Public Service of New Hampshire
NEW HAMPSHIRE YANKEE DIVISION

SBN- 807
T.F. B7.1.2

Subject: Seabrook Station Flood Protection Features Enhancement

REVETMENT B-TYP SECTION # GRADE
(EAST SLOPE)

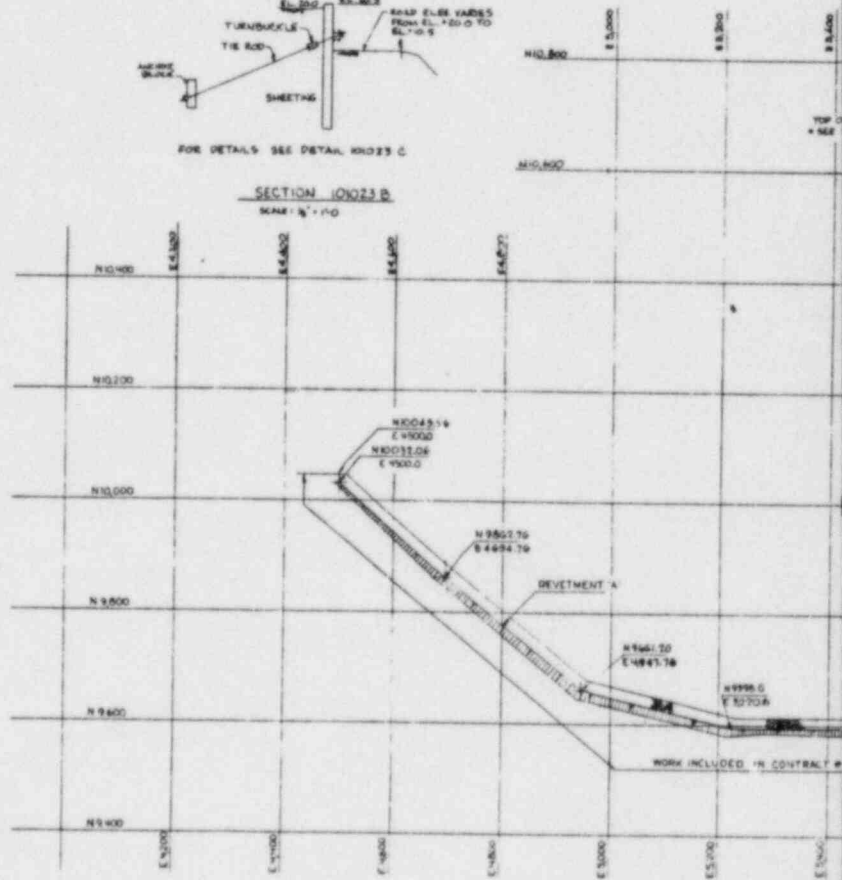
The design of the east and northeast sections of Revetment B (designated on Figure 2.4-20) consists of compacted tunnel cuttings. For erosion protection, Revetment B will be faced with quarrystone as defined in Table 2.4-13 and on Figure 2.4-23. The east section of Revetment B will have a slope of 1 on 3. The northeast section of Revetment B will have a nominal slope of 1 on 2.5 that varies from 1 on 1.9 to 1 on 2.5. This variation in revetment slope will allow Rocks Road to have a 12 foot width without infringing on the marsh.
